LiDAR Quality Assessment Report

Project ID:
ARRA Contract # W912EE-07-D-0005

Project Description:
MS Delta Yazoo Phase 1 2009-2010 LiDAR encompassing all of Tunica, Coahoma, Quitman, Tallahatchie, Leflore, Sunflower, Bolivar, Washington, Humphreys, Sharky and Issaquena Cos., and the western-central area of Warren, Yazoo, Holmes, Carroll, Grenada, Yalobusha, Panola, Tate and Desoto Cos. in Mississippi. Contract W912EE-07-D-0005

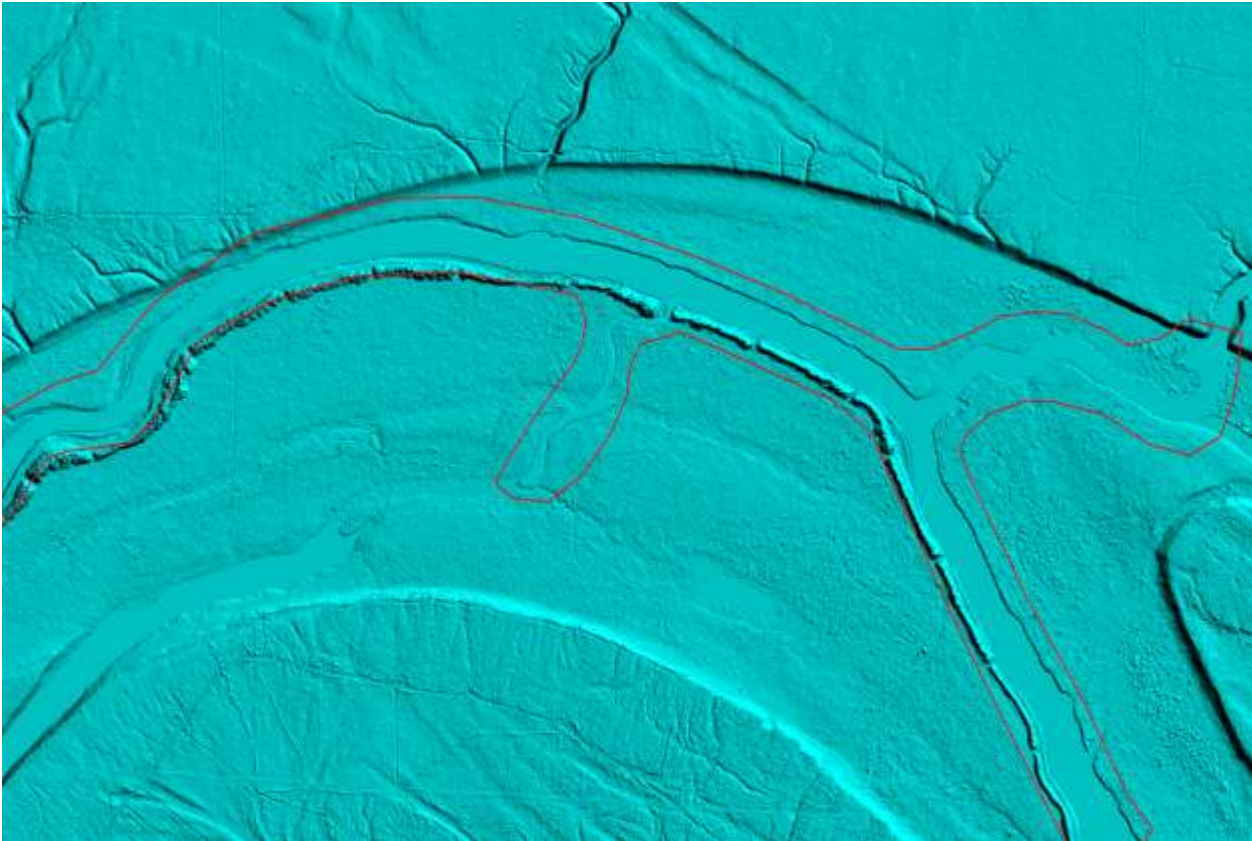
Floating water in stream located @ 32° 29' 18.5772" N, 90° 54' 36.6213" W

**Fixed by vendor.

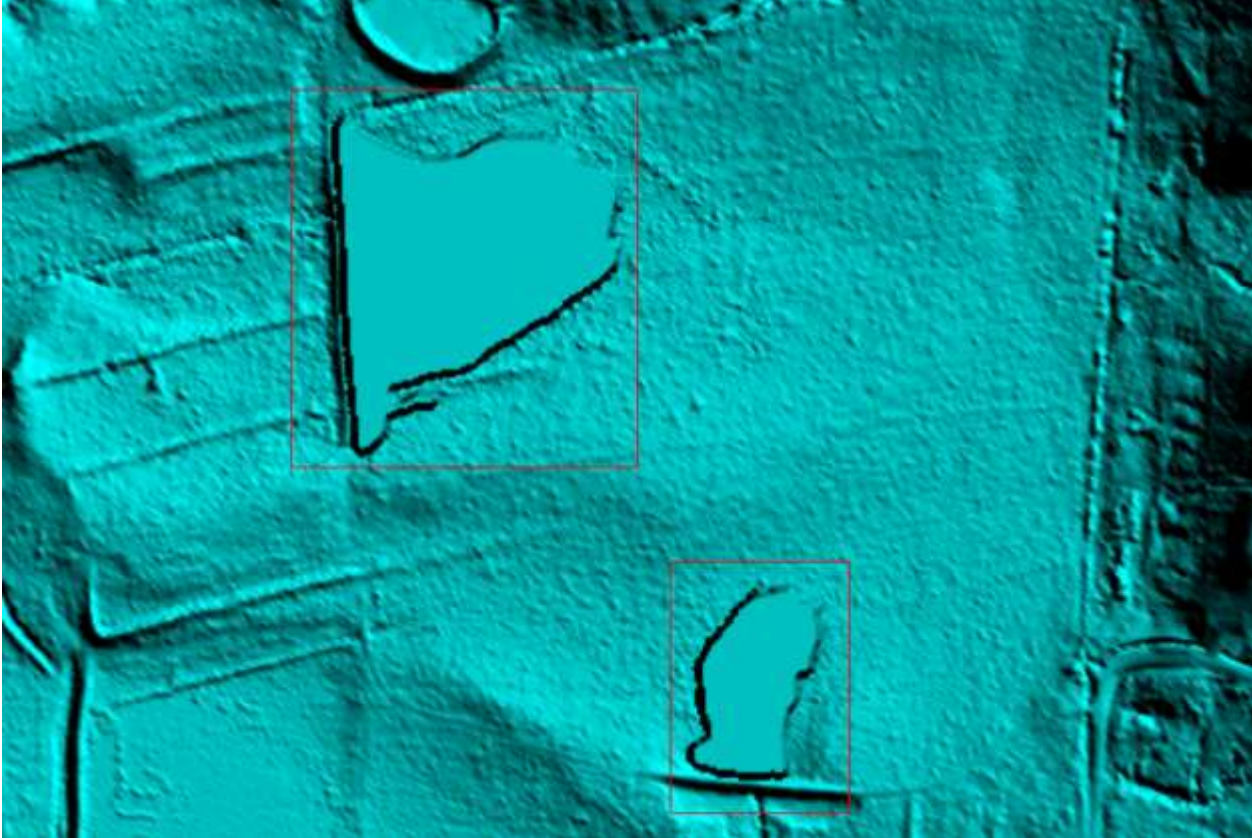
2 extremely high floating water bodies @ 33° 45' 29.7636" N, 89° 46' 35.9173" W

**Fixed by vendor.

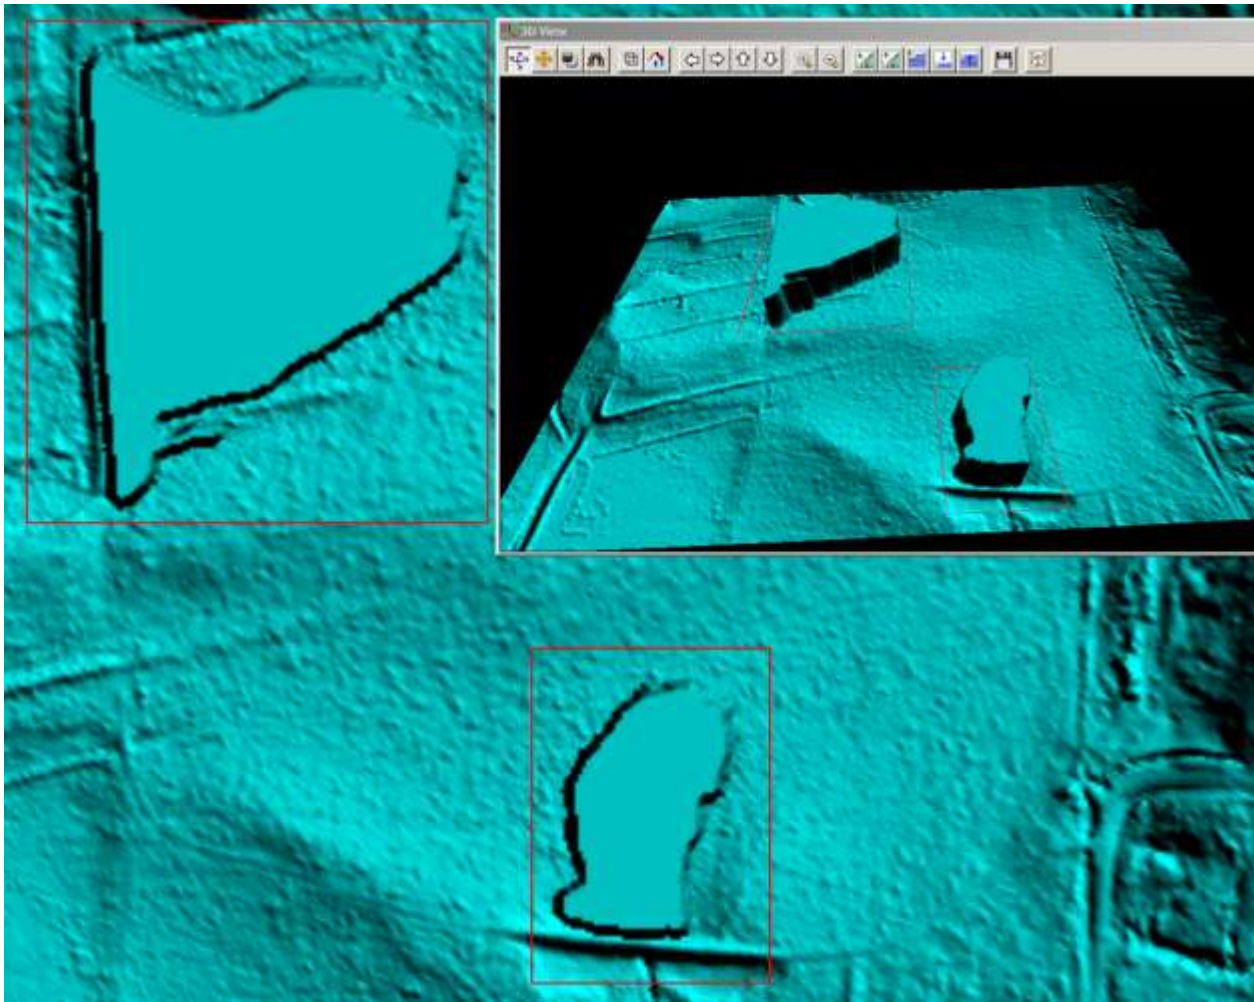
extremely high floating water bodies in 3 D

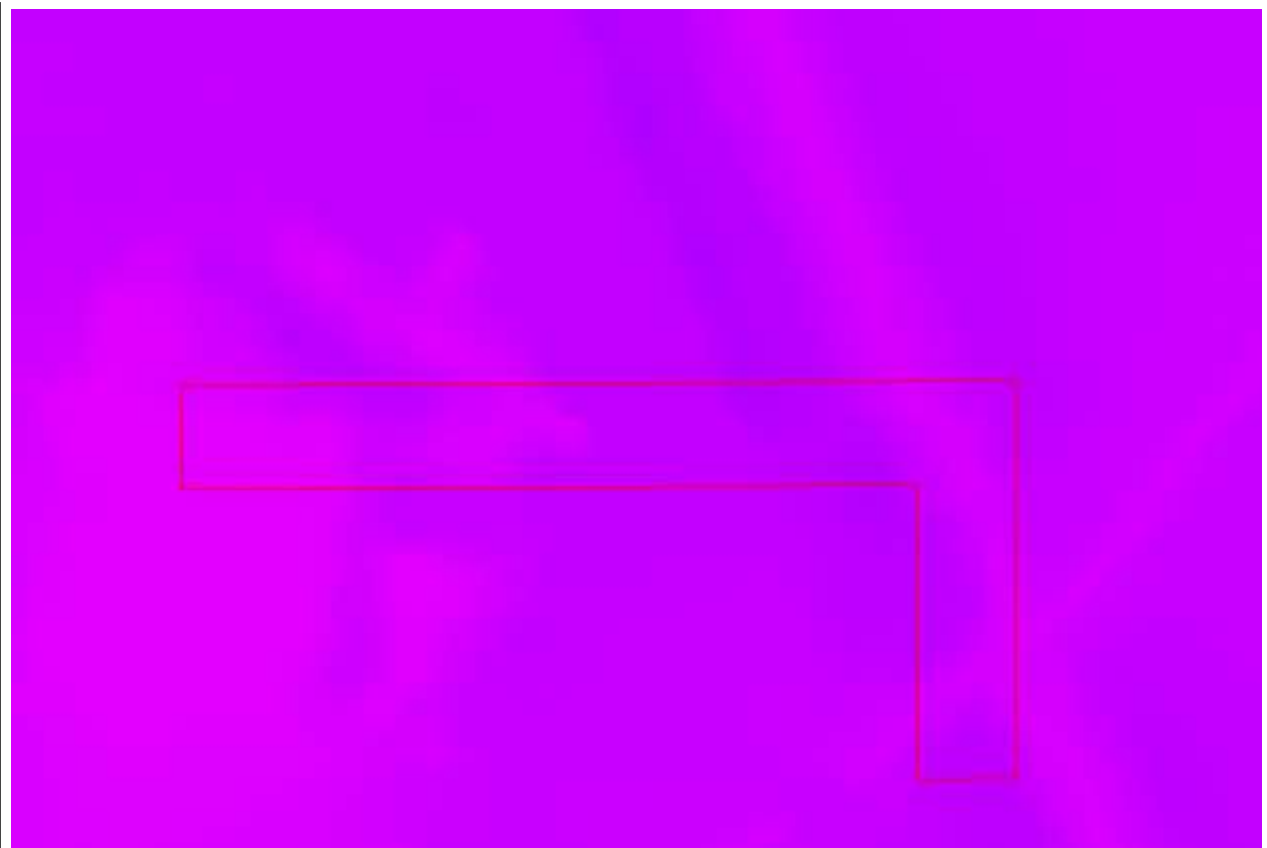
seam visible in DEM with hillshade off

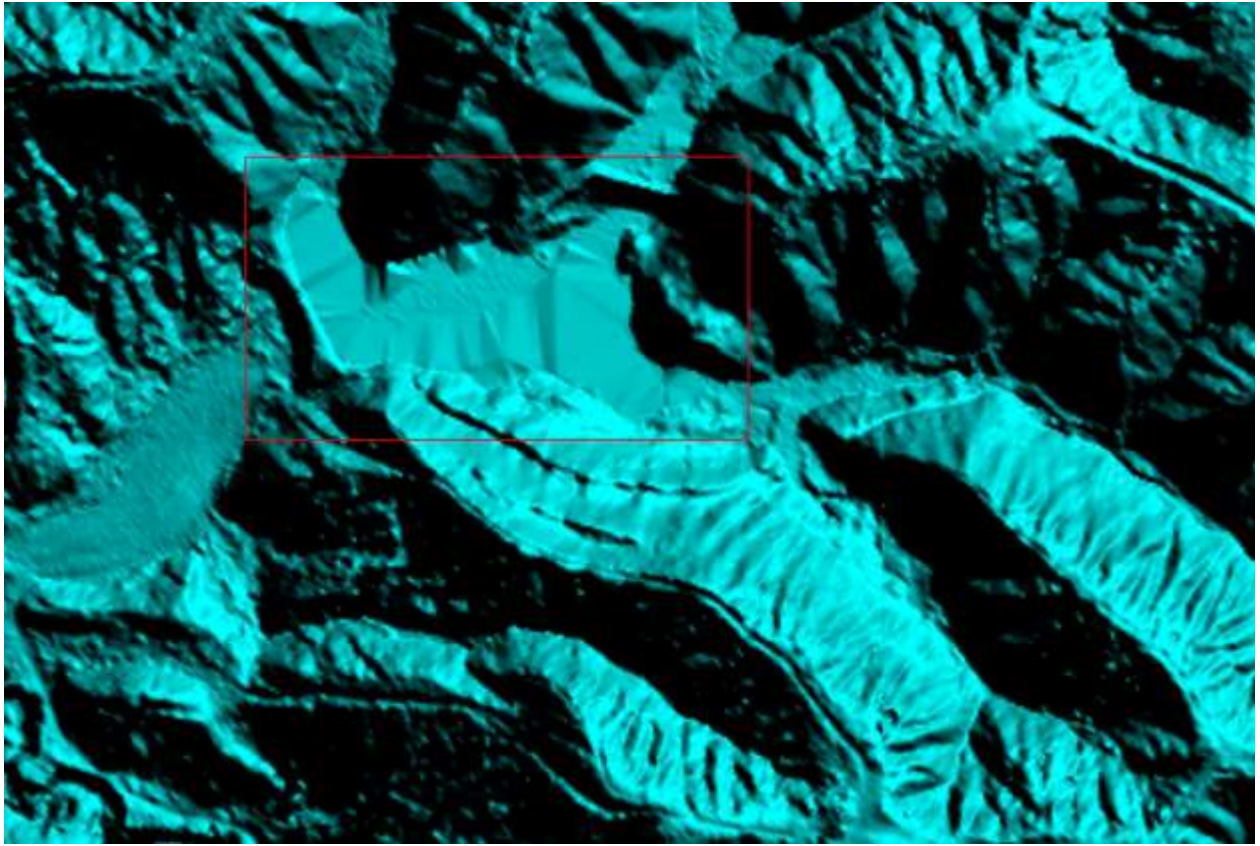
water body > 2 acres to be flattened @ 32° 34' 45.3030" N, 90° 36' 58.8762" W

**Fixed by vendor.

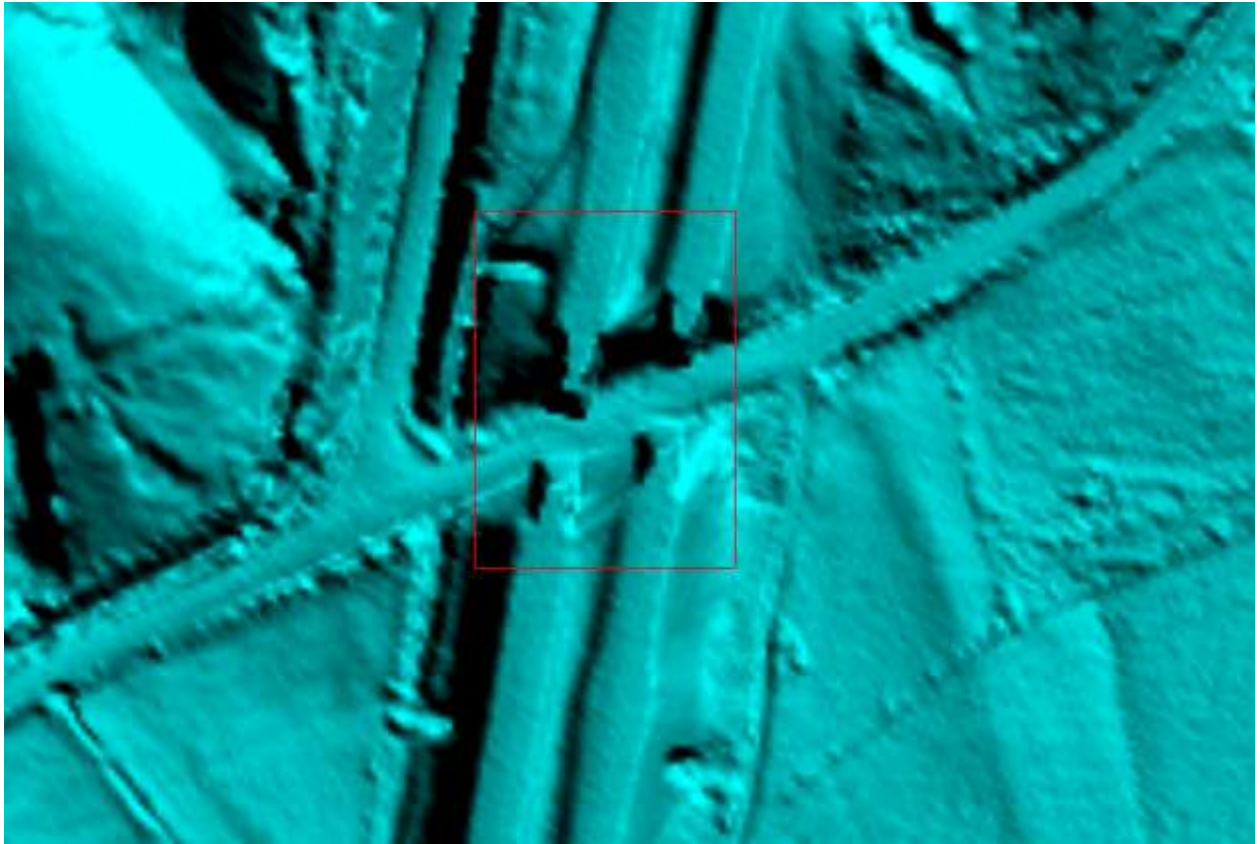
bridge remnants located @ 34° 22' 35.9114" N, 89° 54' 36.4581" W

**Fixed by vendor.

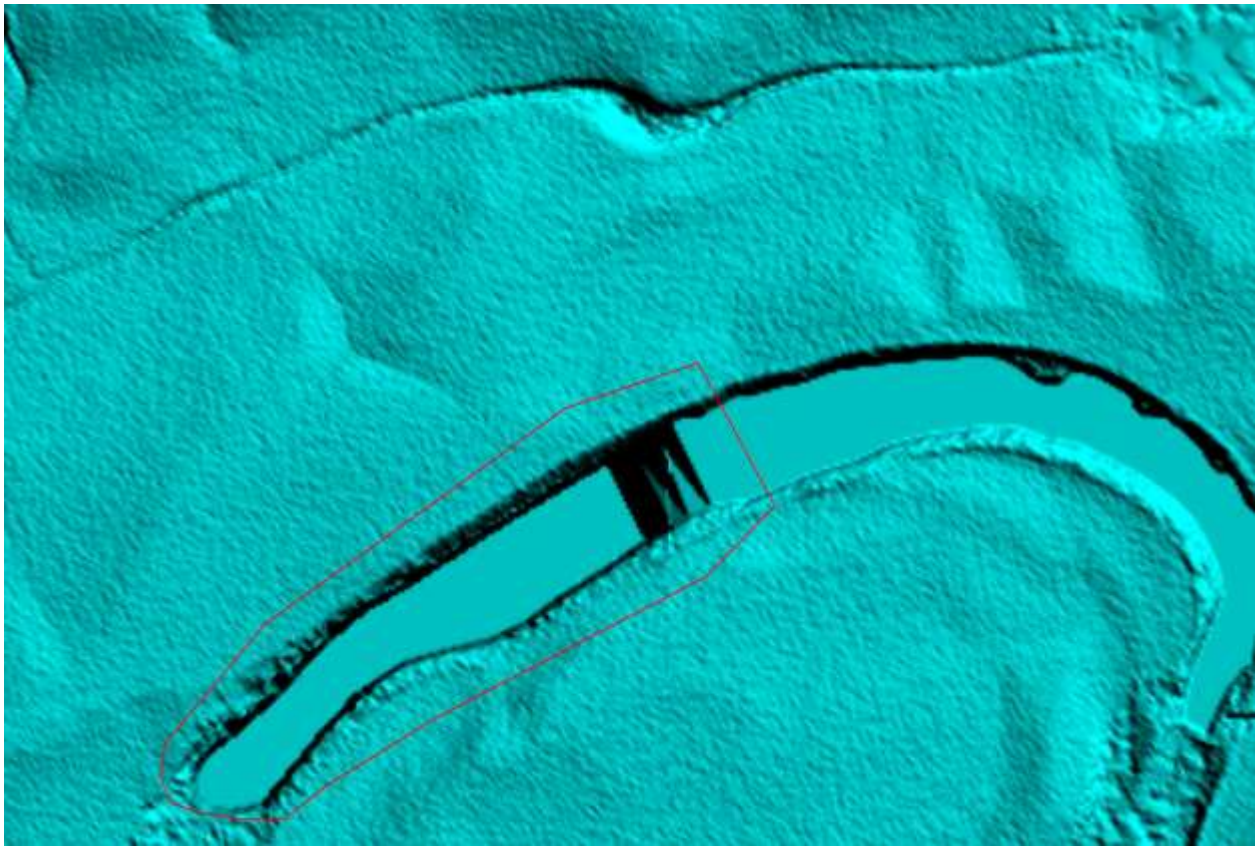
improperly processed data in 2 tiles @ 33° 30' 49.2868" N, 90° 36' 4.9846" W

**Fixed by vendor.

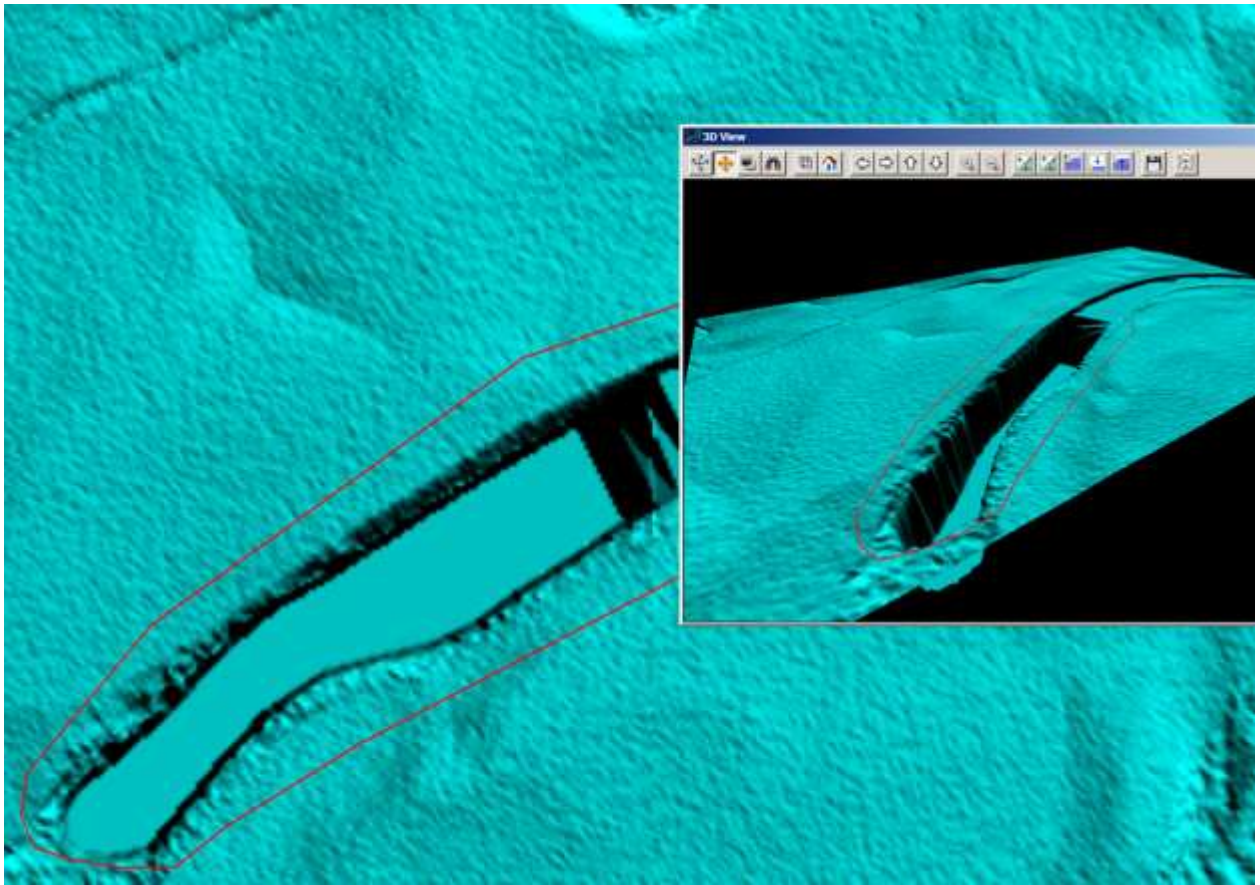
shoreline too deep due to breaklines @ 33° 49' 52.6121" N, 90° 09' 30.9743" W

shoreline too deep in 3D

**Fixed by vendor.

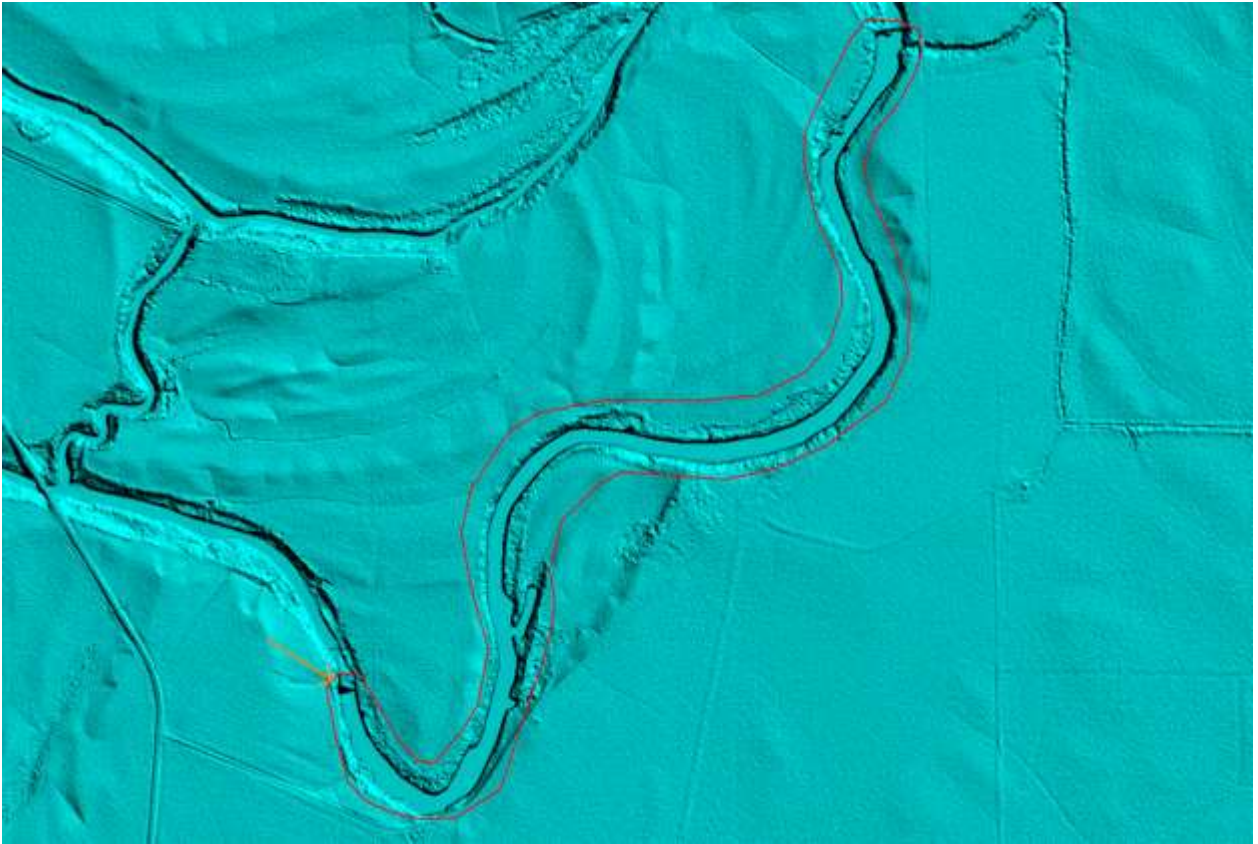
water body too deep & spike at seam line located @
33° 51' 49.7145" N, 90° 09' 26.3740" W

**Fixed by vendor.
